OAKDALE WEST ESTATE - SSDA 7348 - MOD 5 Submission Civil Changes

This letter addresses the primary changes in the design at Oakdale West Estate for the Masterplan and the Precinct 1 on-lot design for the Modification No. 5 Application to SSDA 7348.

Project
PROPOSED INDUSTRIAL DEVELOPMENT OAKDALE WEST

Title
**SITEWORKS AND STORMWATER DRAINAGE PLAN
SHEET 5 OF 14**

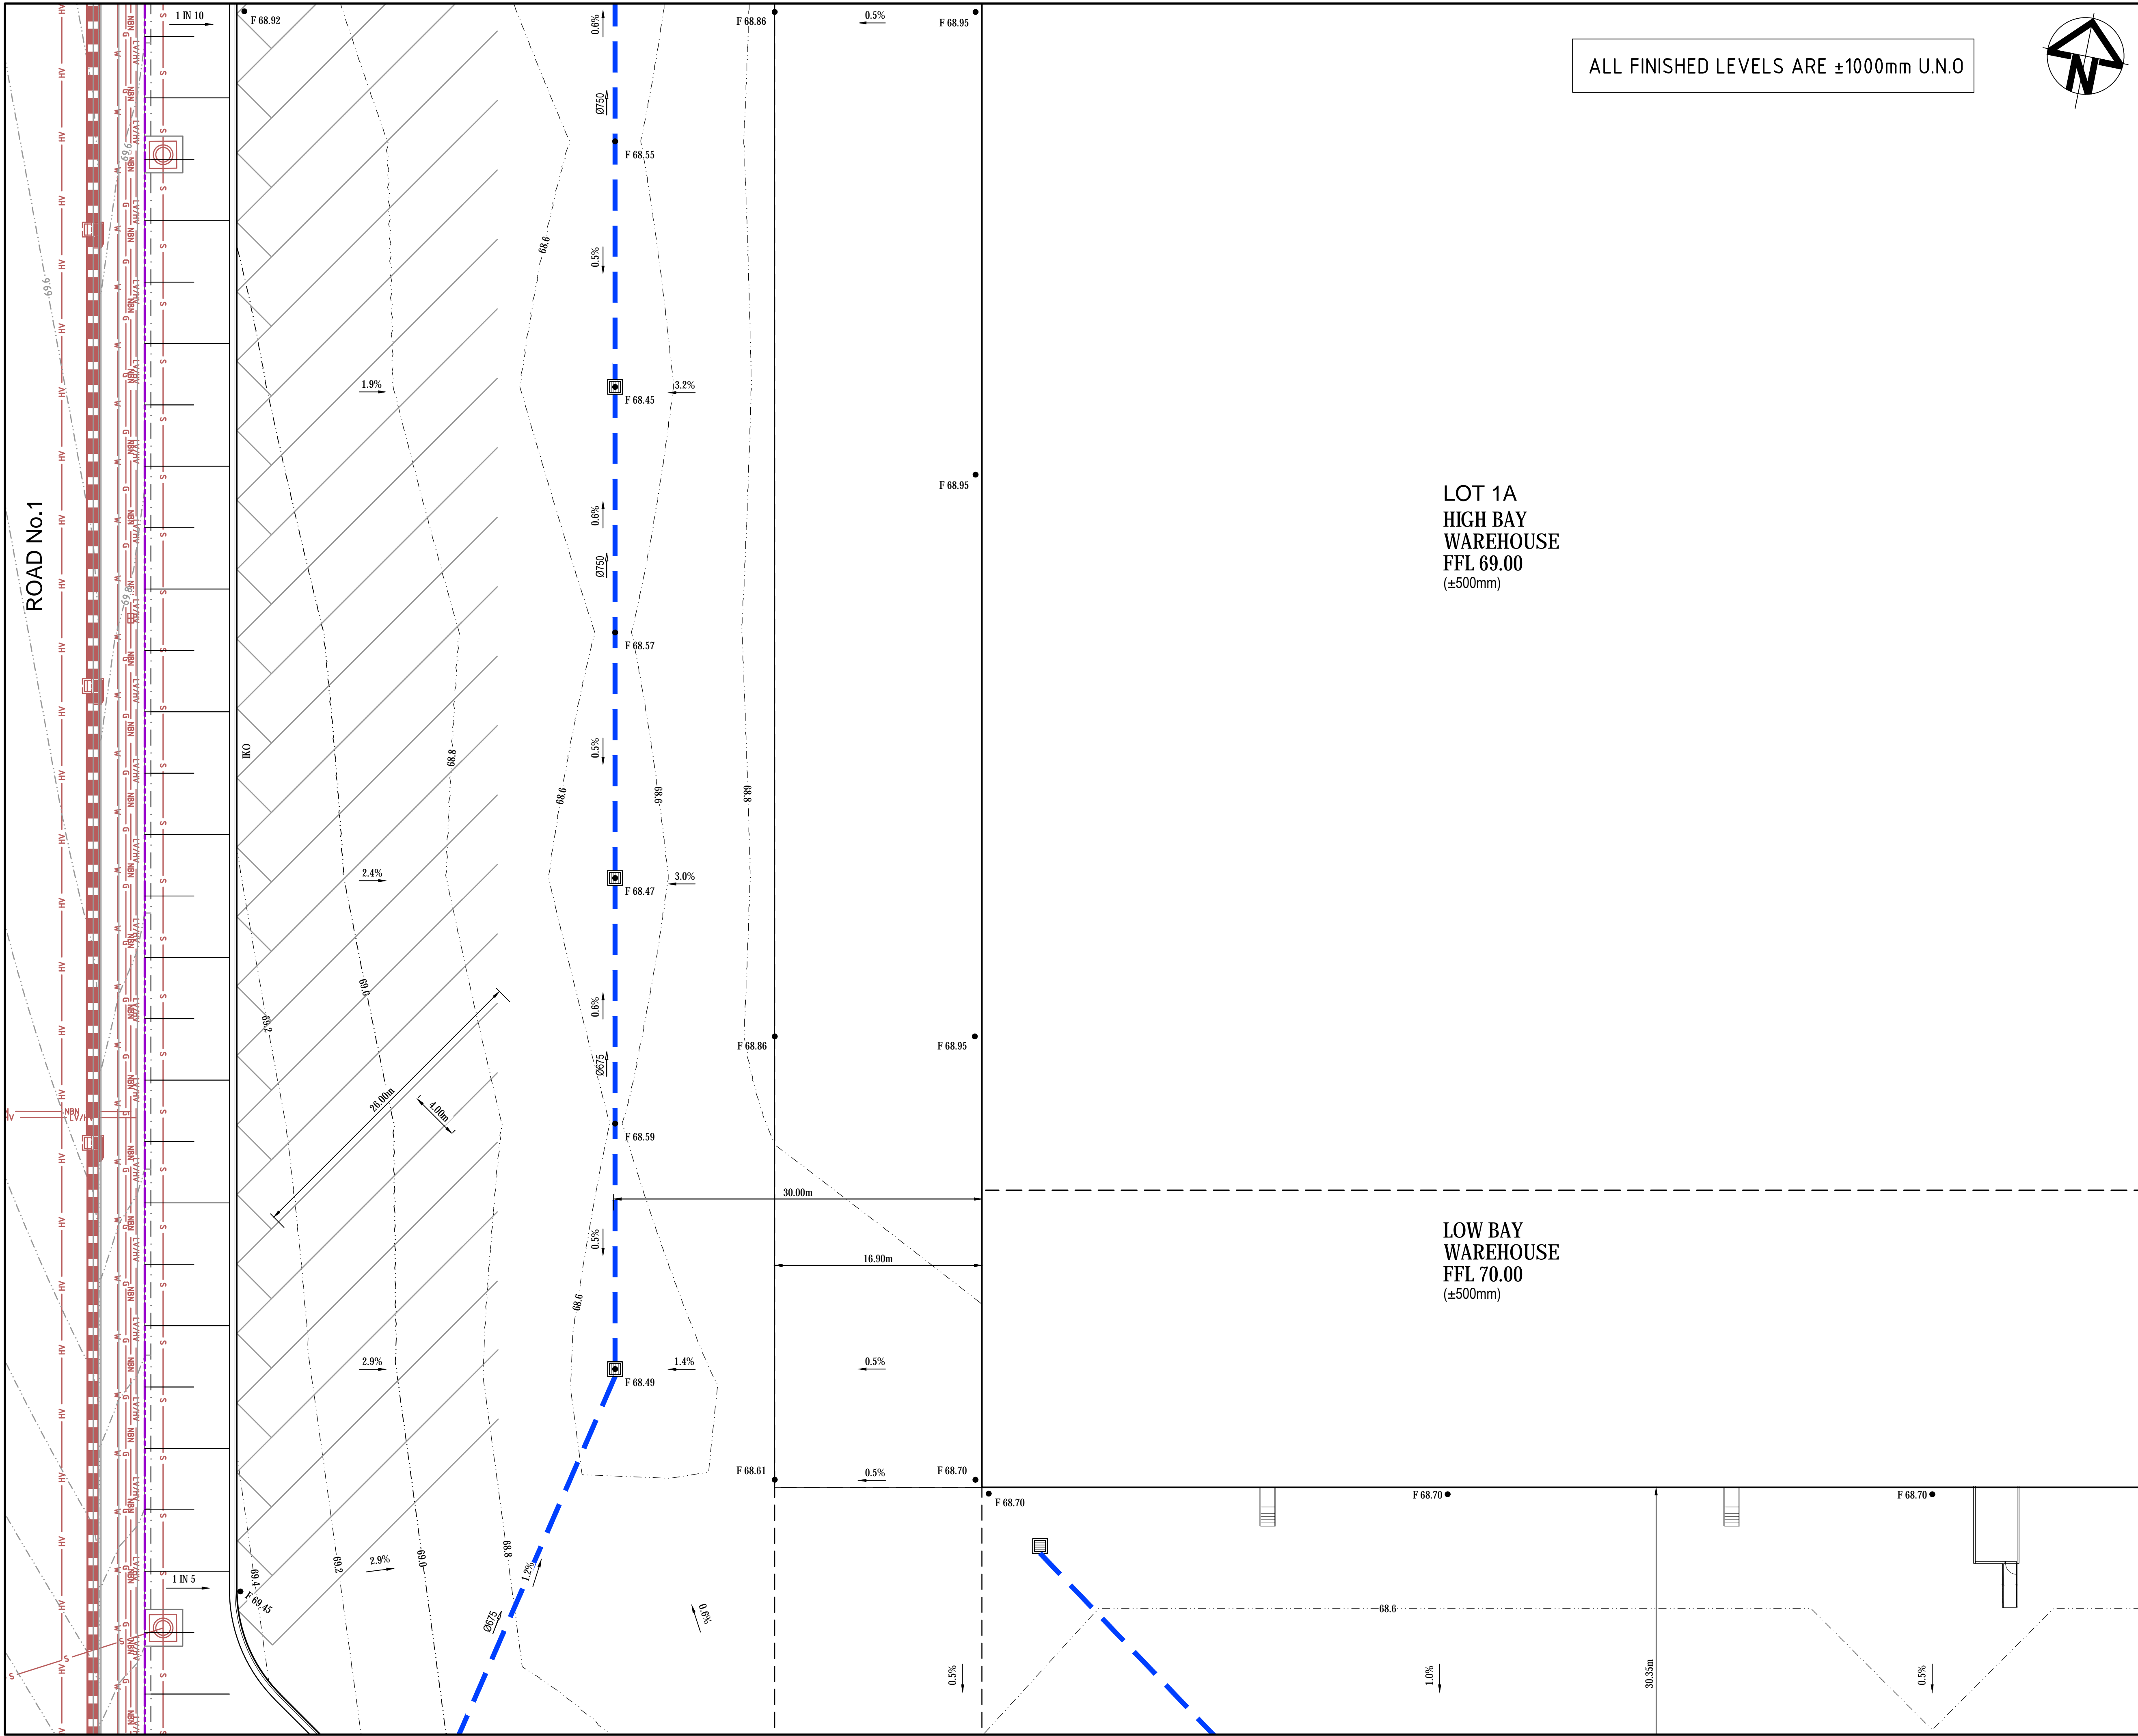
The Lot 1A and 1B layout has been updated to rearrange the carparking and hardstand areas in line with the architectural changes. The stormwater catchments and overland paths remain very similar and have no impact on the modelling for the infrastructure throughout the estate. This is shown on drawings C2000-C2030.
